WARRANTY BULLETIN

CAN-AM® ROADSTER

Subject: **A - Fast Flasher Blink Rate**

No. **2014-2**

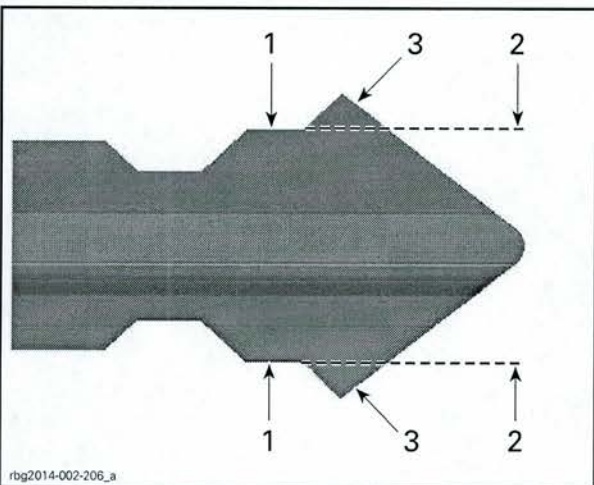
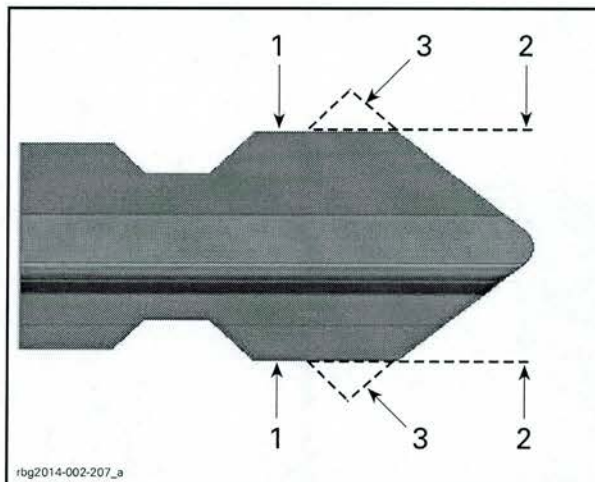
2. Using a small rotary tool, grind off the last point on both sides of the end of the key.

NOTE: The height of the last flat surface will vary with the key code. The modified surface **must** be in line with and square to the last flat surface of the key.

1. Reference flat surface
2. Cut line
3. Material to remove

1. Reference flat surface
2. Cut line
3. Material removed

► D.E.S.S. Antenna Replacement ◄

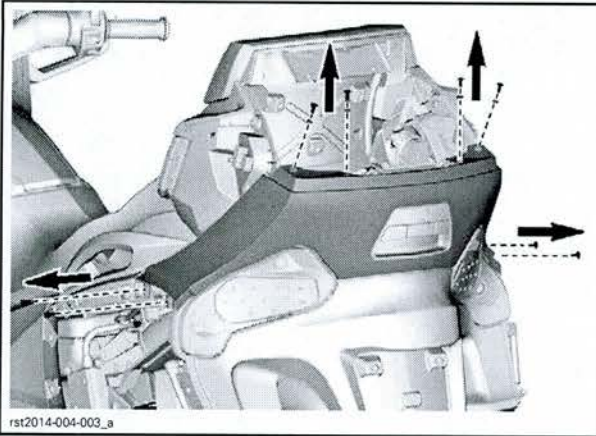
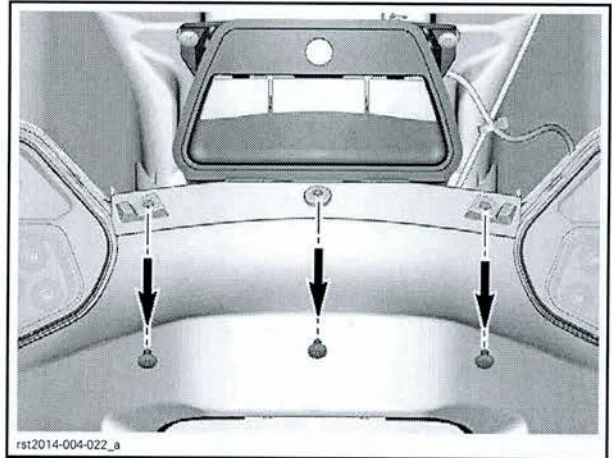
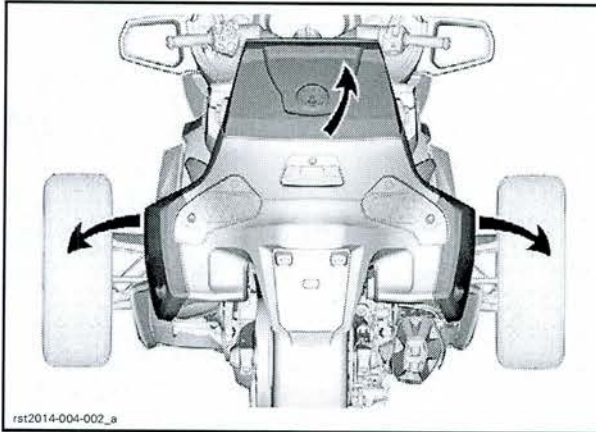
► Follow procedures as detailed in references except for the following:

- On all models, remove the console module (see *PROCEDURE REFERENCES*).
- Do not remove the front cargo module.
- Do not disconnect the D.E.S.S. antenna at the D.E.S.S. module. Instead, remove the D.E.S.S. antenna from the ignition switch already in the vehicle and install it on the new ignition switch assembly. Refer to *D.E.S.S. ANTENNA REPLACEMENT* further in this bulletin.

1. ► Carefully pry off the D.E.S.S. antenna from the OLD switch before removing the switch from the vehicle.

2. Carefully pry off the D.E.S.S. antenna from the NEW switch.

3. Position NEW ignition switch near handlebar and install the OLD D.E.S.S. antenna on the new switch.

4. Connect NEW ignition switch to vehicle harness.
